Author Details	
Name	Dr Andrew Boswell
Position	Independent Scientist & Consultant
A57 Link Roads Registration	20029126
Organisation	Climate Emergency Policy and Planning (CEPP)
Examination Principle Issues	<ul style="list-style-type: none"> • Climate Change • Scope of Development and Environmental Impact Assessment • Benefit cost ratio (BCR) and case for scheme

DEADLINE D12 SUBMISSION

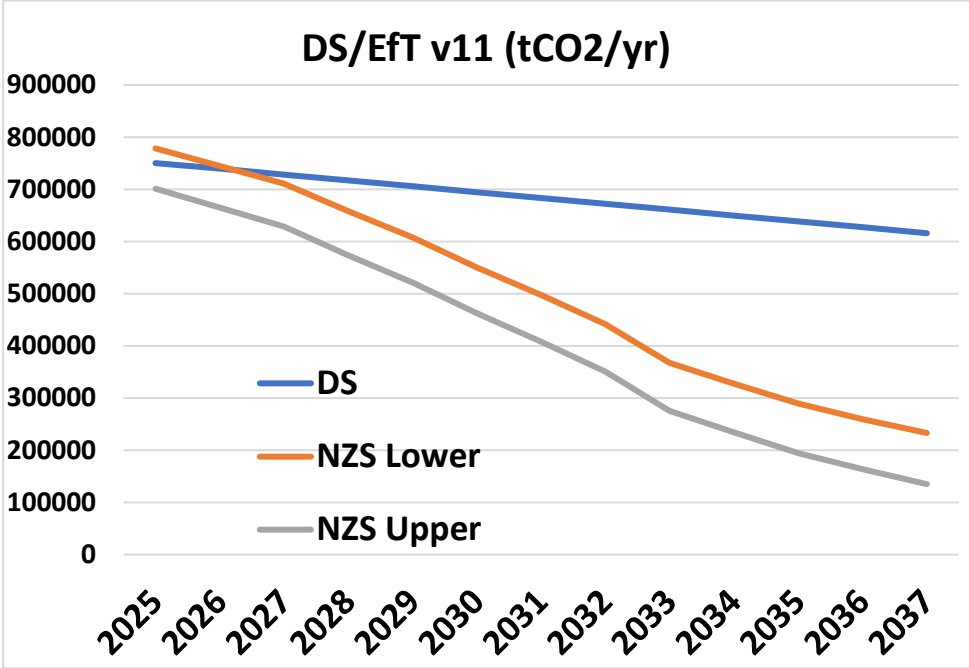
32 A more realistic way to look at the uncertainty here is given by my narrative under the graphs in REP11-020/3.5. The DS graph is reproduced below with narrative.

“Where TDP policies are successful, the blue line will move towards the orange and grey upper/lower NZS lines, but as there is no carbon quantification of TDP policies, nor data supporting that they are designed to secure their emission reduction objectives, it is impossible to make any claim about how much the blue will move towards the orange and grey lines.”

33 Where the applicant says *“The emission change with the Scheme for the TDP delivery pathway assumptions would be **anticipated** to fall between the upper and lower bound values given in REP5-026.”*, this is the proposition 3 of the “overarching assertion of TDP success”. No evidence has been provided that the TDP will inevitably succeed, and therefore it cannot be anticipated to do so. The applicant is making the leap of blind faith not just that the blue

line will move towards the orange and grey upper/lower NZS lines, but that it will move all the way to lie between the orange and grey upper/lower NZS lines. No evidence has been provided that this is realistic, or that the TDP and NZS have been designed to secure this outcome.
